SERVICE BULLETIN

ENGINE - FUEL AND CONTROL - REWIRE THE DATA ENTRY PLUG (DEP) TO THE APPLICABLE WIRING CONFIGURATION - CATEGORY CODE 8 - MOD.ENG-73-0035

V2500-ENG-73-0035

Location of the Data Entry Plug Assembly
Fig.1

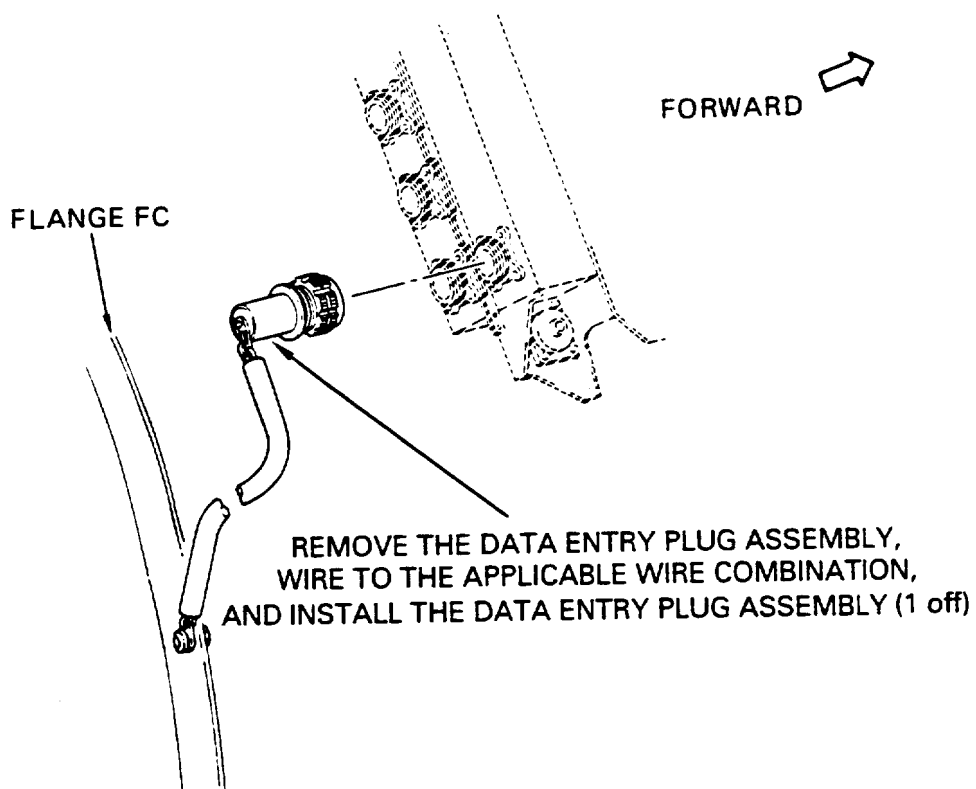
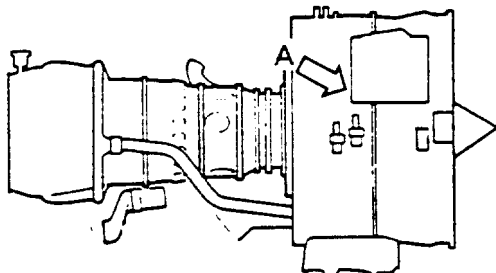
- (1) For Engines V0207 through V0303 do an inspection of the DEP Backshell by the instructions given in Reference (2).
- (2) Do a modification of the 5A0431, 5A0432, 2A2309CL01, or the 2A2309CL02 Data Entry Plug Assembly (See Reference (3), Chapter/Section) 71-00-00, Testing-11 and as follows:

- (a) Wire the Data Entry Plug to the 00 Bump configuration for engines that will not use Thrust Bump.
- (b) Wire the Data Entry Plug to the 01 Bump configuration for engines that will use the Cyprus Bump.
- (c) Wire the Data Entry Plug to the 03 Bump configuration for engines that will use the Consolidated Thrust Bump.
- (d) Wire the Data Entry Plug to the 04 Bump configuration for engines that will not use the Thrust Bump, but will use the 5 Deg. C Bias (applied to measured EGT).
- (e) Wire the Data Entry Plug to the 05 Bump configuration for engines that will use the Cyprus Bump and the 5 Deg. C Bias (applied to measured EGT).
- (f) Wire the Data Entry Plug to the 07 Bump configuration for engines that will use the Consolidated Thrust Bump and 5 the Deg. C Bias (applied to measured EGT).

NOTE: When you change the wire configuration of the Data Entry Plug Assembly you must do a check to make sure the new configuration is correct. Use the electrical tester specified. See Reference (3), Chapter/Section 71-00-00, Testing-11.

Location Of Engine Identification Plate
Fig.2

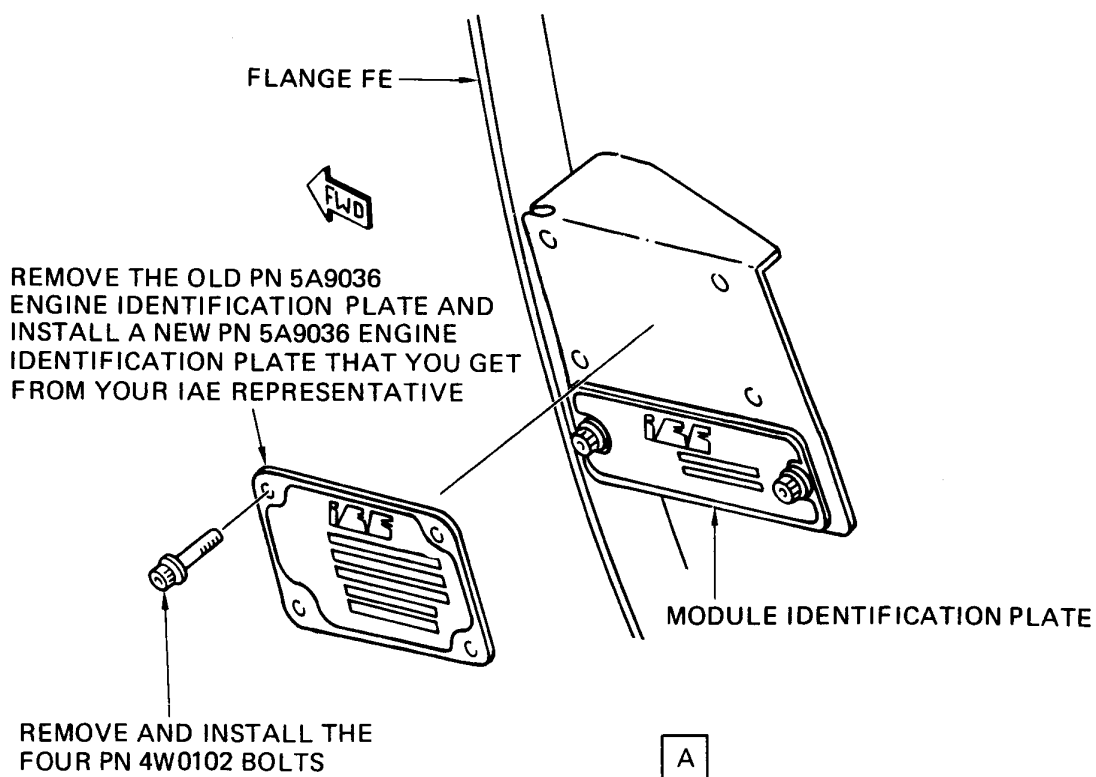
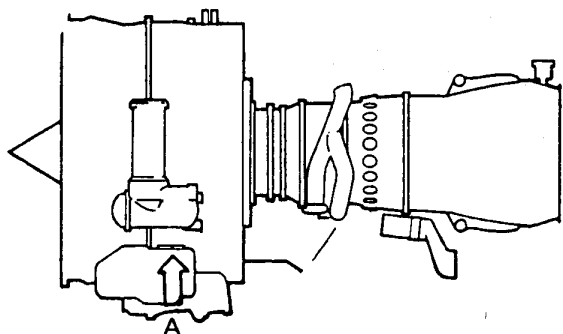
- (1)
 - (a) Remove the four bolts that hold the Engine Identification Plate to the bracket located on the fan case at the 9 o'clock position. See Figure 2.
 - (b) Give the old Engine Identification Plate to your local IAE Representative.

- (c) Get the new 5A9036 or 5A1465 Engine Identification Plate marked with the engine serial number, data entry plug part number, and take-off rating, from your IAE Representative.

- (d) Install the new Engine Identification Plate to the bracket with the 4W0102 Bolts (4 off). See Figure 2.

- (e) Torque the bolts between 32 – 36 lbfin (3,61 – 4,07 Nm).
